## Access Compliance Report Public Rights-of-Way (Curb Ramps)

Intersection ID: 28422 Main Street: ASTONBORO\_DR Cross Street: CHASTAIN\_PARC\_DR Location: S

ADA ID: 6EDD58402716 Ramp Type: Perp Initial Pass/Fail: Fail Overall Compliance: No Severity Score: 46.25

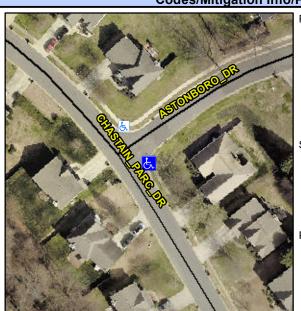
Not Found, R304.5.1, R304.2.2, R304.5.3

R304.5.3

Field Measurements/Component Compilance					
Compliance Description		Data	Compliance Description		Data
N/A	Ramp Length (in)	46.5	No	Ramp Slope (%)	10.2
No	Ramp Width (in)	47.0	No	Ramp XSlope (%)	7.7
N/A	Flare Type LT	N/A	N/A	Flare Type RT	N/A
N/A	Flare Slope LT (%)	N/A	N/A	Flare Slope RT (%)	N/A
N/A	Flare Traversable LT?	N/A	N/A	Flare Traversable RT?	N/A
N/A	Landing Length (in)	N/A	N/A	DWS Provided?	N/A
N/A	Landing Width (in)	N/A	N/A	DWS Contrast?	N/A
N/A	Landing Slope (%)	N/A	N/A	DWS Length (in)	N/A
N/A	Landing X Slope (%)	N/A	N/A	DWS Full Width?	N/A
N/A	Landing Curb? (Y/N)	N/A	N/A	DWS Offset (in)	N/A
N/A	Shared Landing?	N/A			
N/A	Gutter Ponding?	N/A	N/A	Gutter Slope (%)	N/A
N/A	Gutter Lip Ht (in)	N/A	N/A	Gutter X Slope (%)	N/A
N/A	Painted X Walk1?	No	N/A	Painted X Walk2?	N/A
	X Walk 1 Direction	To N		X Walk 2 Direction	N/A
N/A	X Walk 1 Width (in)	N/A	N/A	X Walk 2 Width (in)	N/A
	X Walk 1 Slope (%)	3.7		X Walk 2 Slope (%)	N/A

Remove & Replace Entire Ramp.
